DRAINAGE CONDITION DISCHARGE

Document Reference. 21458-CCL-LS-002

Planning Application No	137467/JO/2023
Site Location	32-34 Laystall Street, Manchester.
Description	Erection of 9 storey residential building (Use Class C3) comprising 89 residential units (28 x 1 bed and 61 x 2 bed) and conversion of and 3 storey extension to 32-34 Laystall Street for use as offices (Class E) with associated external works following demolition of outrigger and associated structures along with other associated works including access, servicing, landscaping and secure cycle parking.
Applicant Name	Great Places Housing Group

LLFA Drainage comments.

1. Drainage Strategy Layout

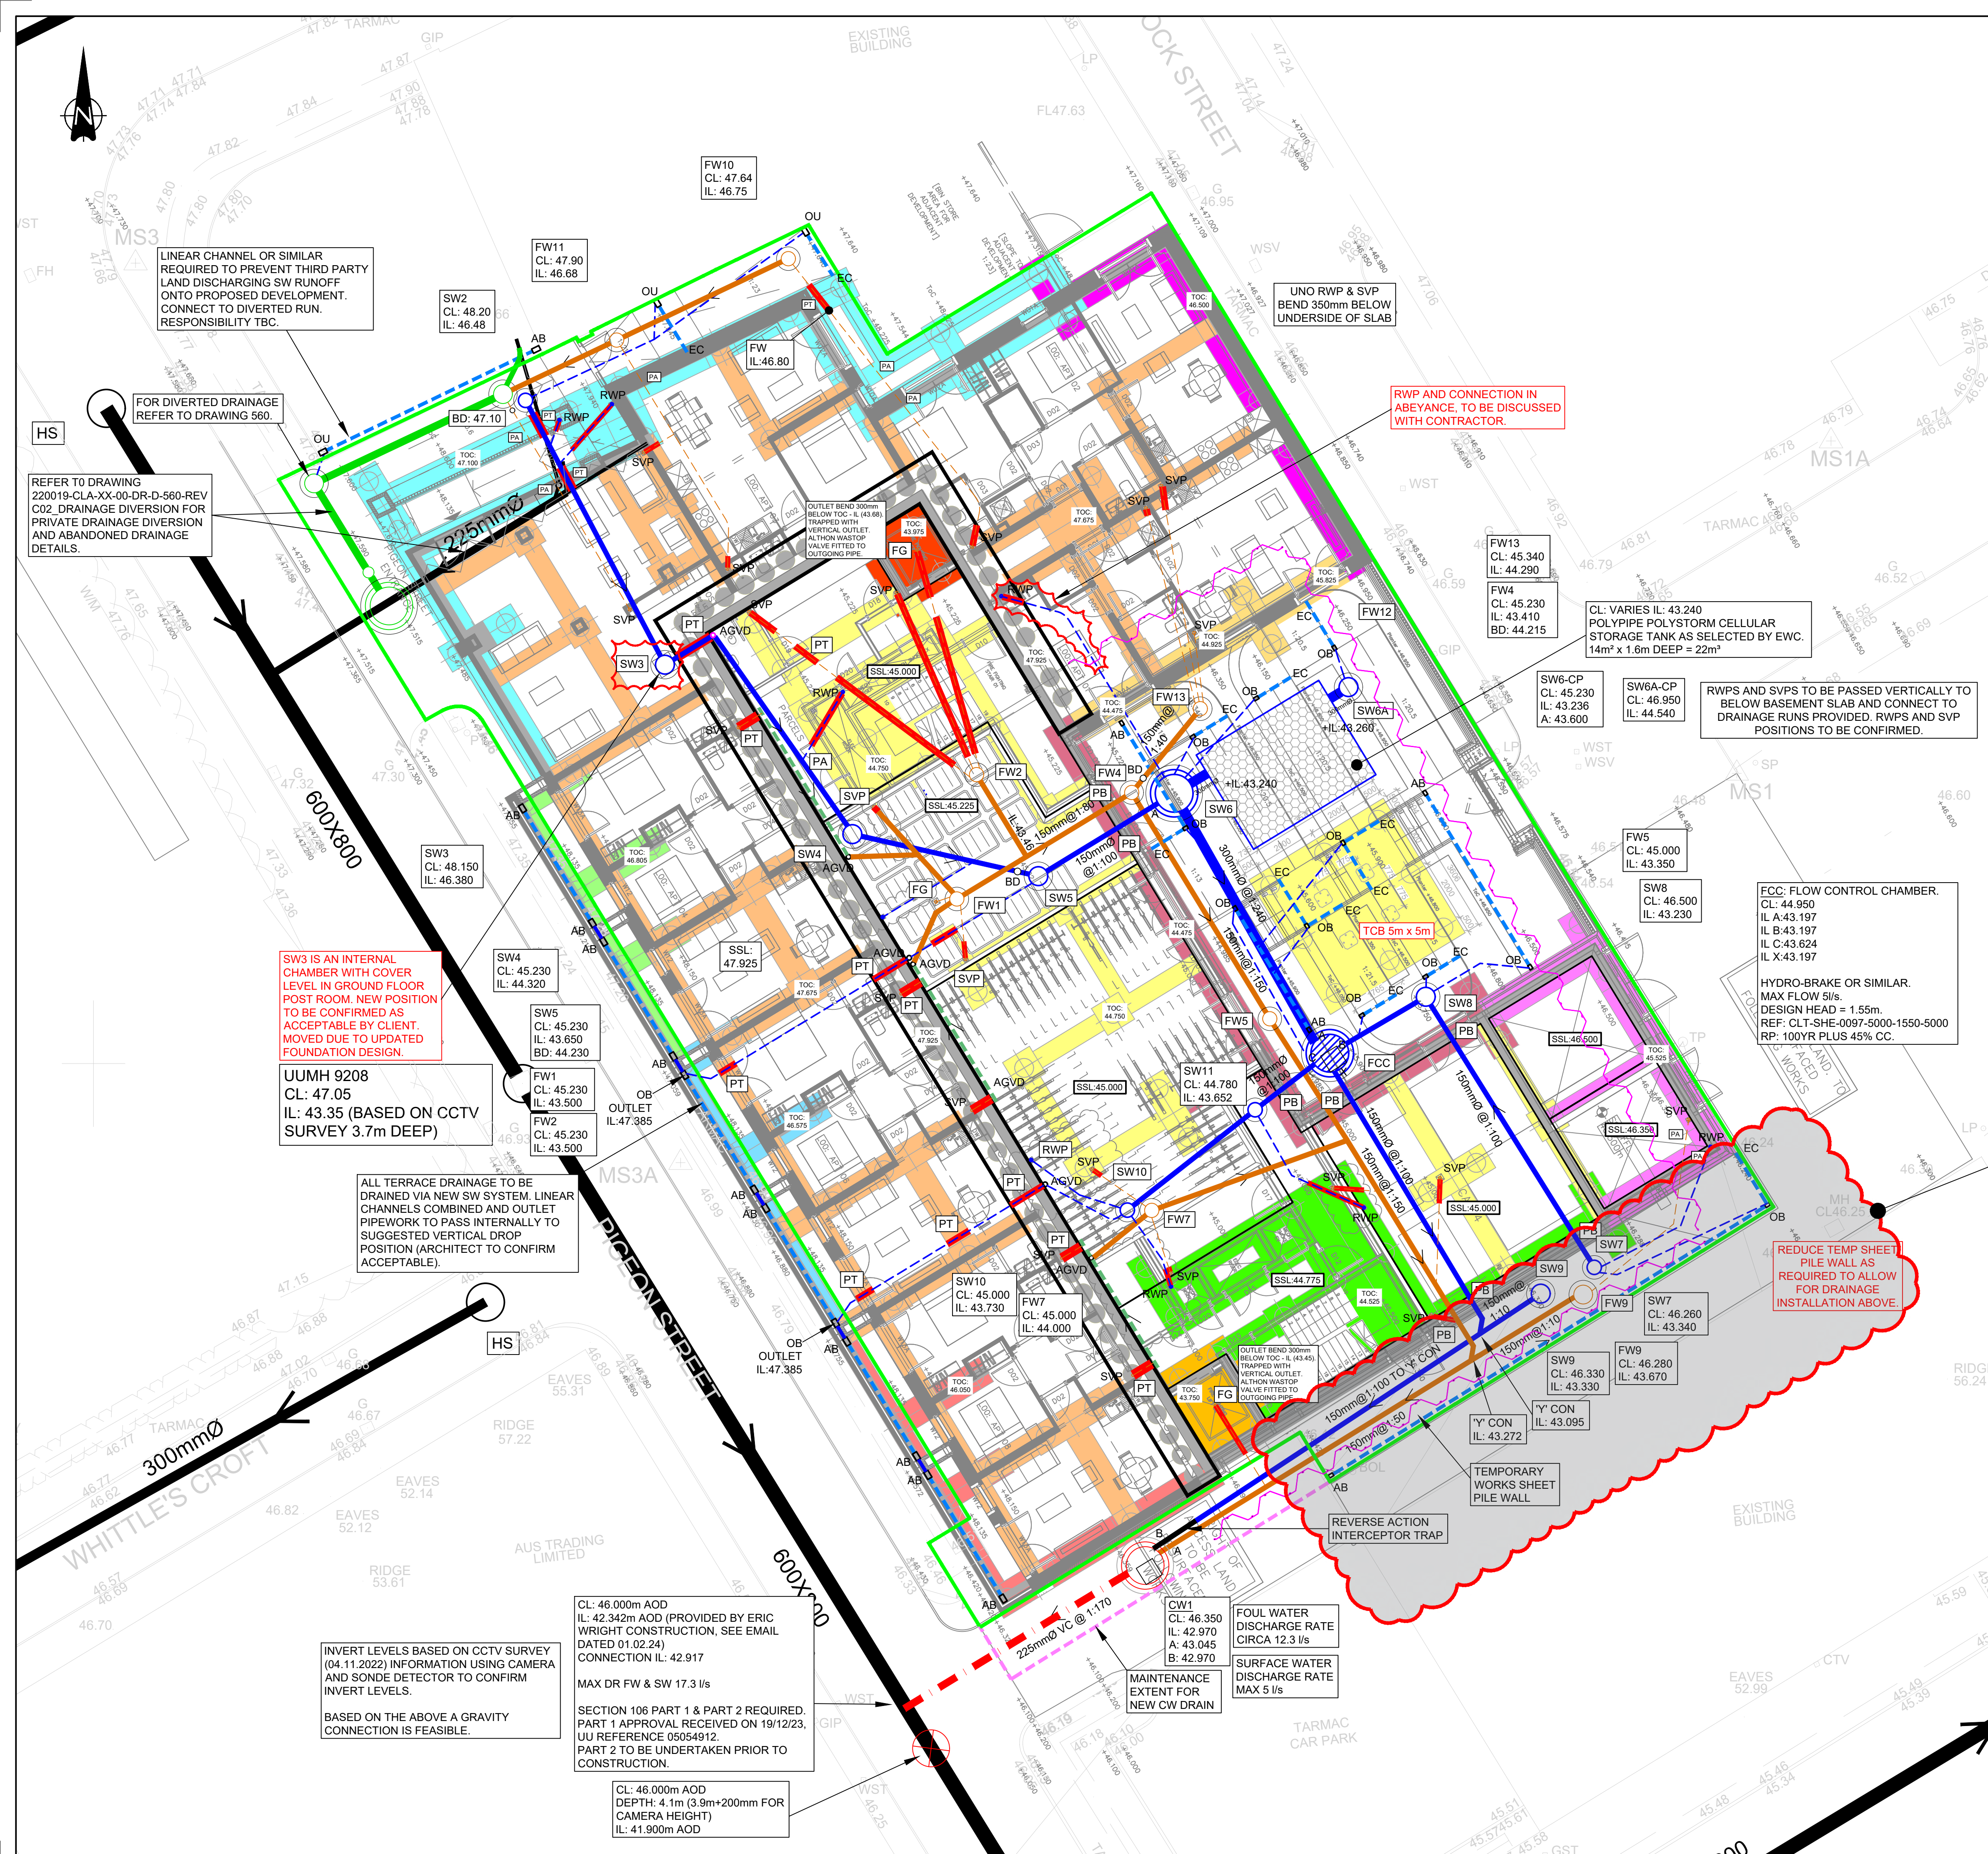
2. The drainage layout should show all drainage elements including systems used to control surface water run-off on site at ground level and should also include the drainage for the refurbished listed building and the northern areas of the site.

Refer to Drainage Layout appended to the back of this document for drainage elements to control surface water run-off. Refer to separate Drainage scheme (1902-LS-DP2-A180-RP-XX-9033 rev P02 Drainage Strategy) and planning condition 7 discharge document for the refurbished listed building and northern areas, by others.

3. UU Connection Approval

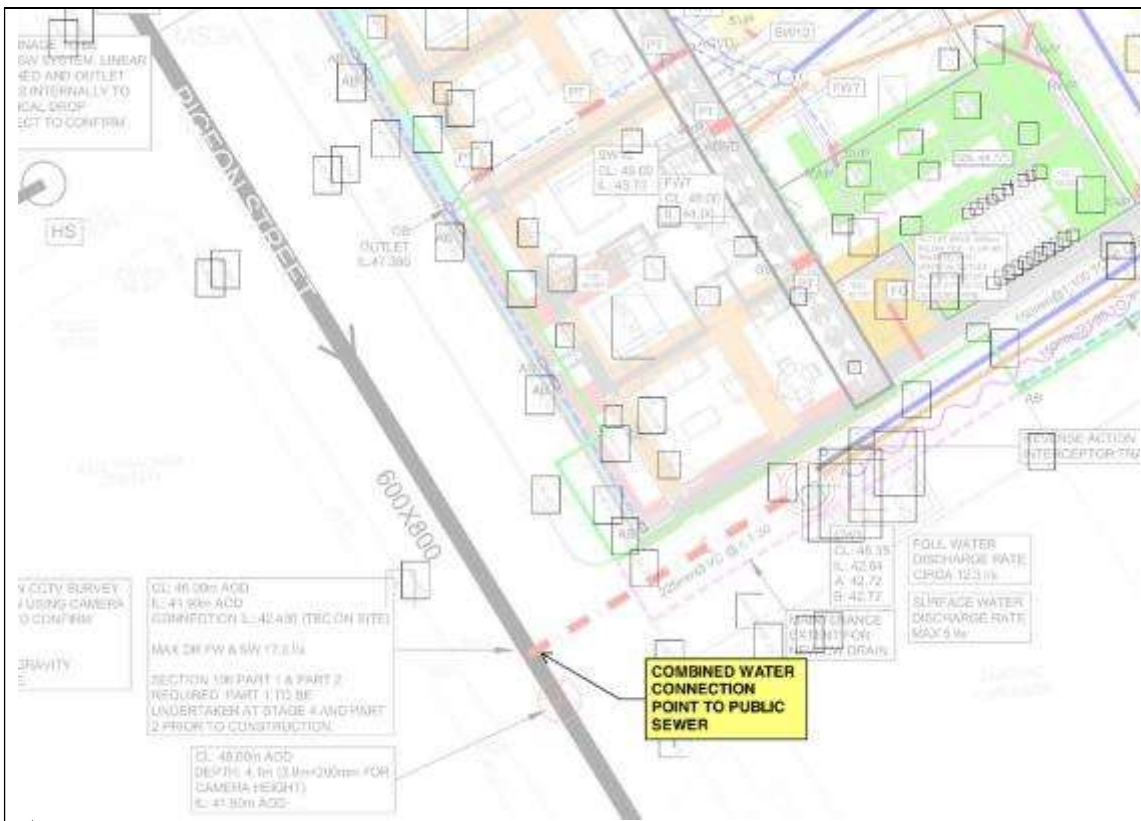
6. Where surface water is connected to the public sewer, agreement in principle from United Utilities is required that there is adequate spare capacity in the existing system taking future development requirements into account. An email of acceptance of proposed flows and/or new connection will suffice.

Refer to correspondence appended to the back of this report containing United Utilities approval of the connection to the Public Sewer in Pigeon Street for surface water and foul water discharge.
